# TECHNICAL BULLETIN

**MODEL/DERIVATIVE:**  
Discovery Series II

**Bulletin N°:** 0077  
**CDS. ref:** L8716bu  
**Issue:** 1  
**Date:** 17.10.01

**PROBLEM:**  
TAIL LAMP CRACKED

A8716dc1

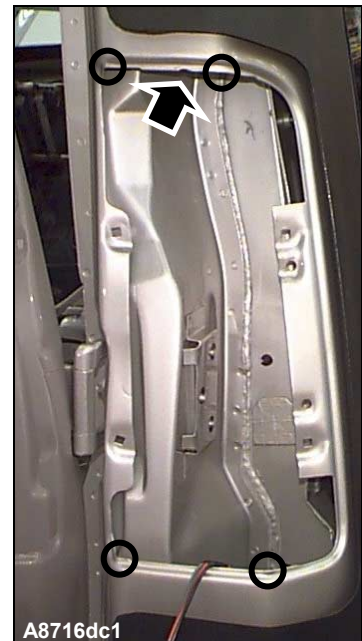
**CAUSE:**  
Due to Body in White specification, stresses can be placed on the tail lamp causing it to crack.

1. Remove tail lamp, refer to Workshop Manual, Lighting, repair number 86.40.70.
2. To remove the stress points on the tail lamp, file 4 small semi circles into the lamp aperture, in areas shown circled on the illustration. Offer the tail lamp to the aperture, noting where on the tail lamp the possible stress points will be. The size of the semi circles should be similar to that arrowed in the illustration.

To ensure that the semi circles will not be seen when the new lamp is fitted, offer the new tail lamp to the aperture before proceeding.

3. Repair paint finish as required. Where bare metal has been exposed, etch prime prior to painting.
4. Fit new tail lamp, refer to Workshop Manual, Lighting, repair number 86.40.70.
